# SUBDIVISION REPORT - CONCEPT/USE ON REVIEW

▶ **FILE #:** 12-SD-21-C  
12-G-21-UR

▶ **SUBDIVISION:** BRIGGS STATION

▶ **PROPOSED USE:** Detached residential subdivision

Sight Distances

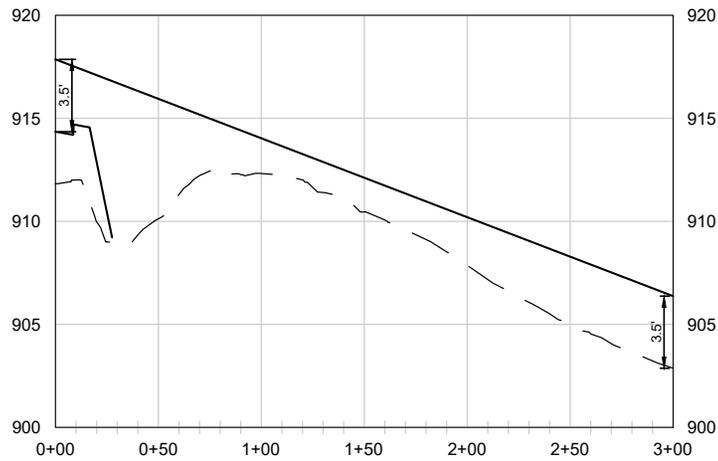
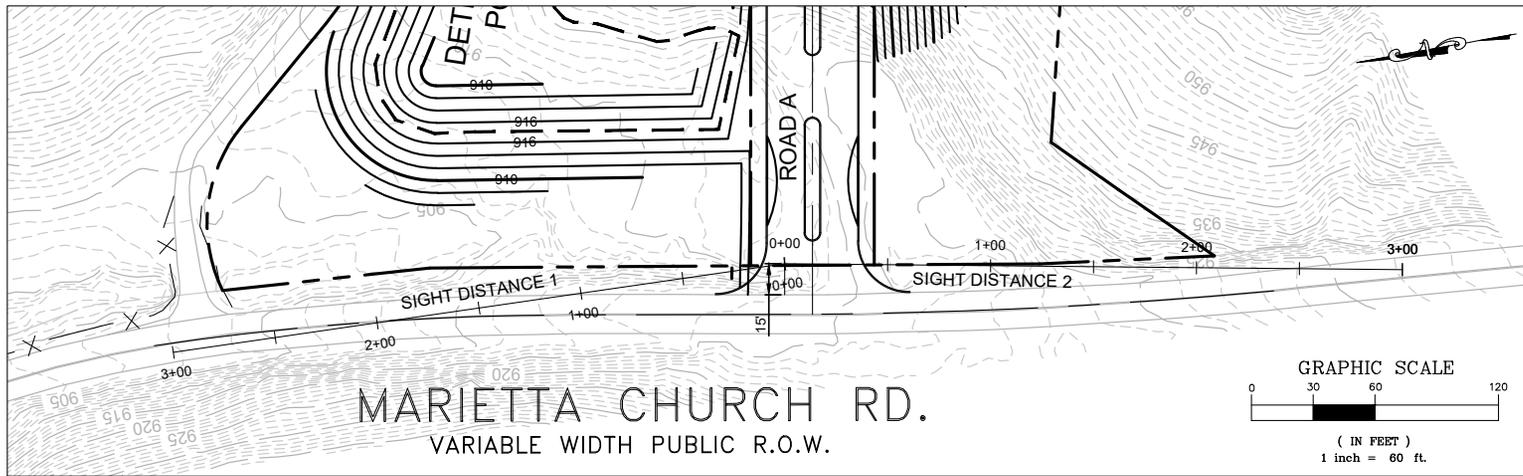
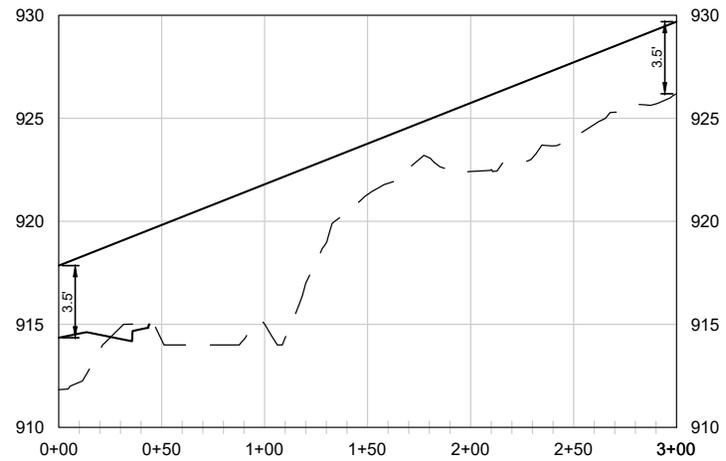
3. Providing a minimum 200 ft sight distance (line of sight) easement on the final plat for all proposed locations on Road 'B' and Road 'C' (lots 22, 29, 103, 105, and 188). The driveways for these lots shall be located outside of the sight distance easement and the driveway locations reviewed and approved by Knox County Engineering and Public Works during the design plan phase and shown on the final plat.

b) A 200 ft sight distance easement must be provided across the lot on the inside of these curves to ensure that objects or plantings do not get installed that will restrict visibility.
